Meeting Minutes

Date: 31 March 2009
Project: Columbine Elementary School - BVSD
Meeting No: 2nd- D.A.T. Meeting

SITE PLAN OPTION THREE

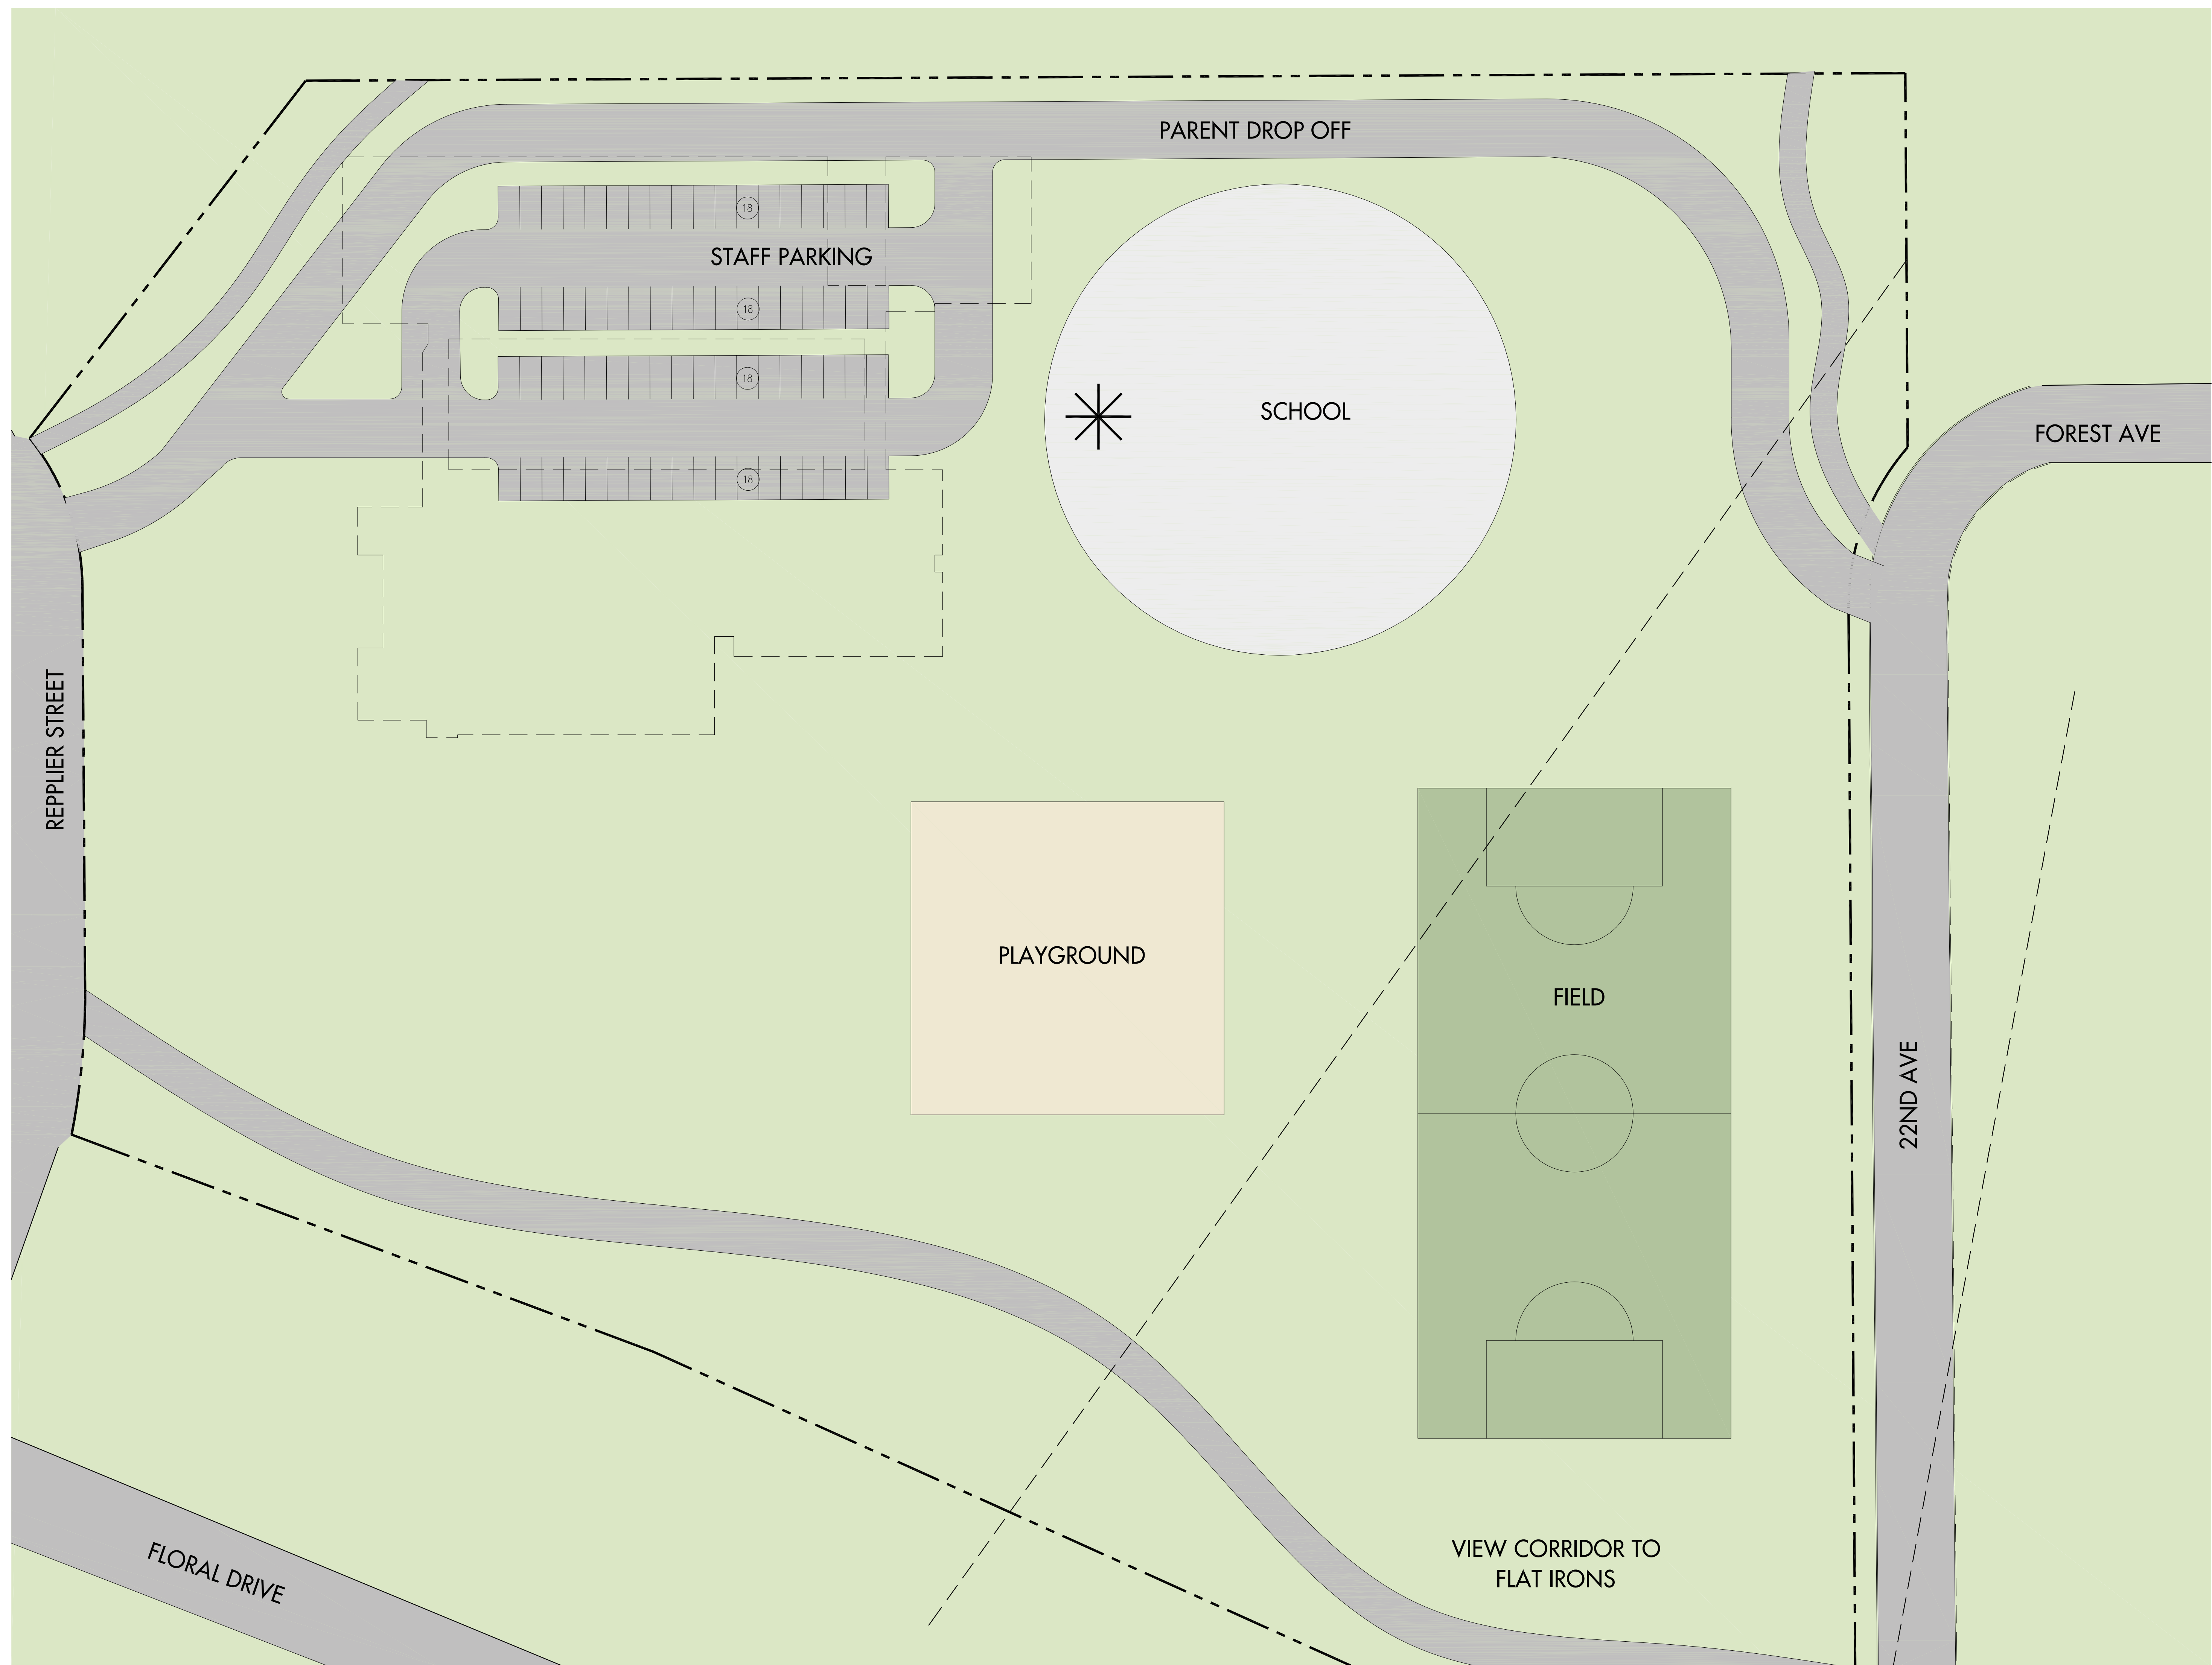
Option 3

- More paving but moves some traffic off Replier to 22nd and Forest.
- The east/west drive is convenient for pickup/drop-off, can provide extra parking for school special event and soccer games on the week-end
- The distance from the parent drop-off to the playground is greater

Concern that the east/west driveway cuts the school off from the park and may disrupt the current use of the green space

Concern that the drive through might be attractive as a bypass (safety and traffic).

The East/West drive removes non-resident soccer parking from the streets.

Majority is opposed to the drive 60/40; however it is recognized that the east/west drive does have some benefits to dissipate parent traffic.

The installation of gates at either end of the drive-through lane would eliminate the possible use of the drive-way as a through street.

COLUMBINE ELEMENTARY SCHOOL
 SITE PLAN OPTION TWO

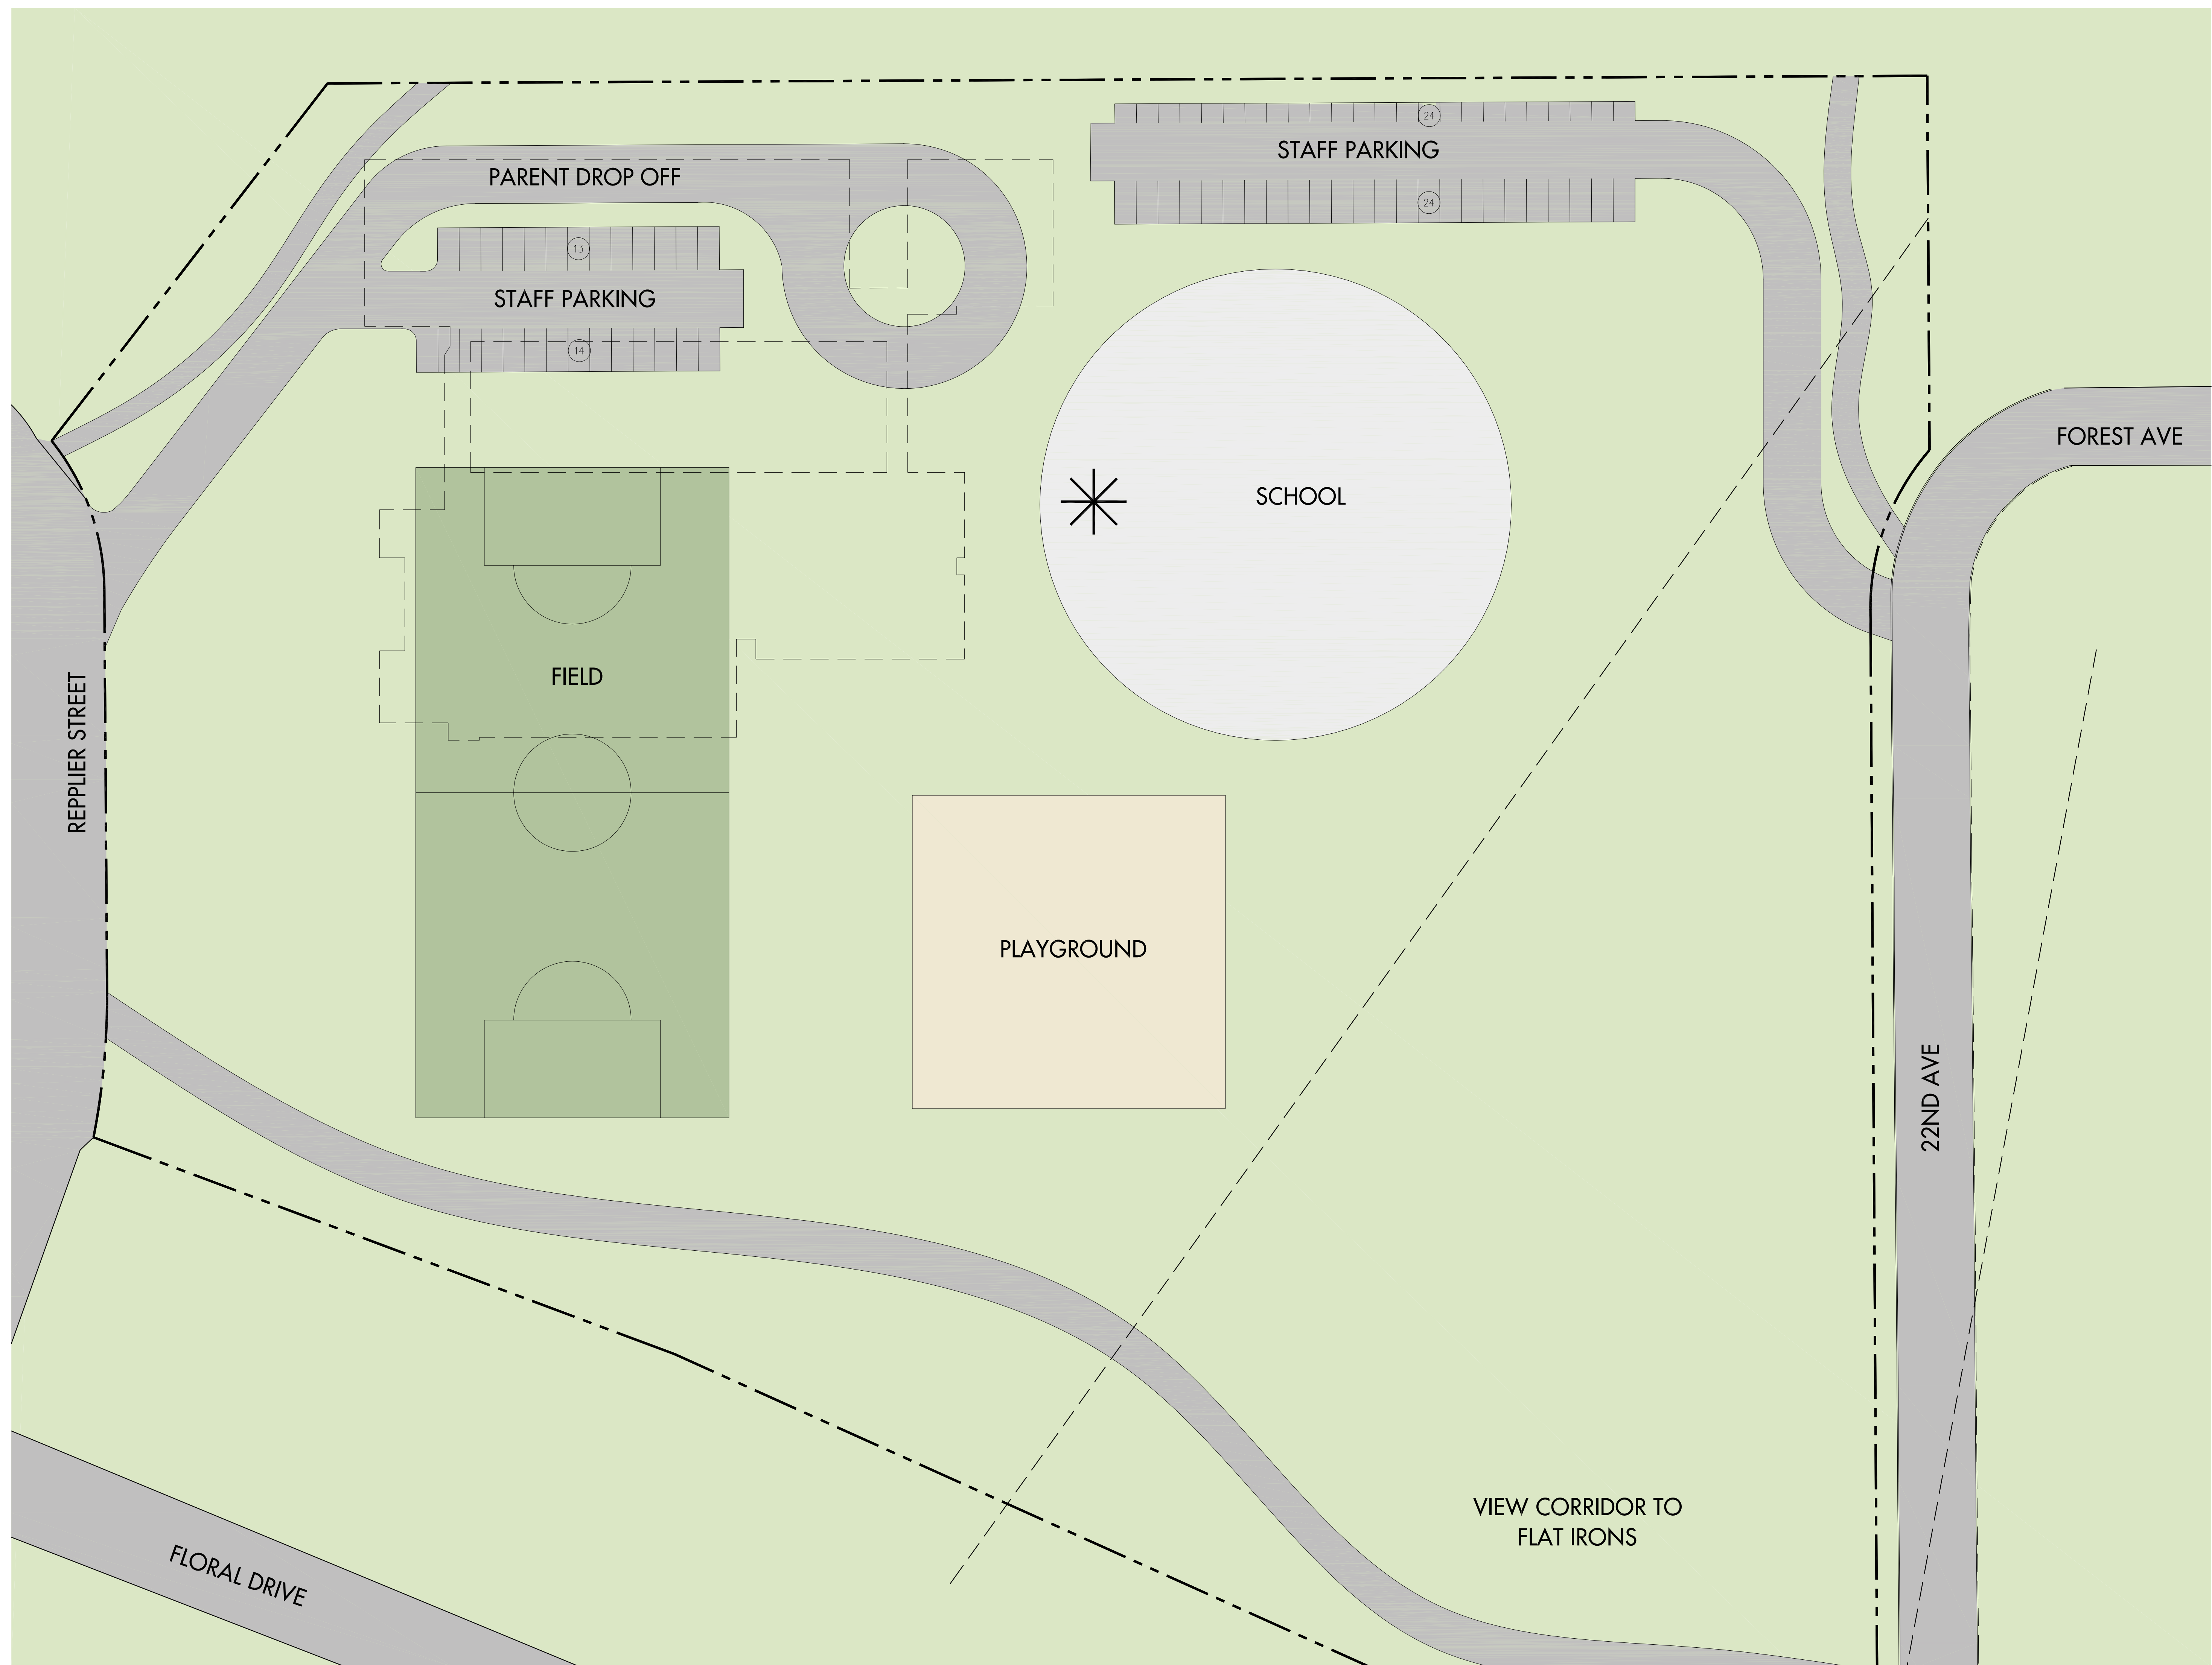
Option 2

- Helps to balance traffic by locating staff parking off 22nd.
- Parking on the north side of the school is not good design and create icy conditions to access the building
- Great separation of staff/visitor parking and parent drop off.
- Location of playfield on the west side of the site requires removing some trees.
- Keeps the paved areas to a minimum
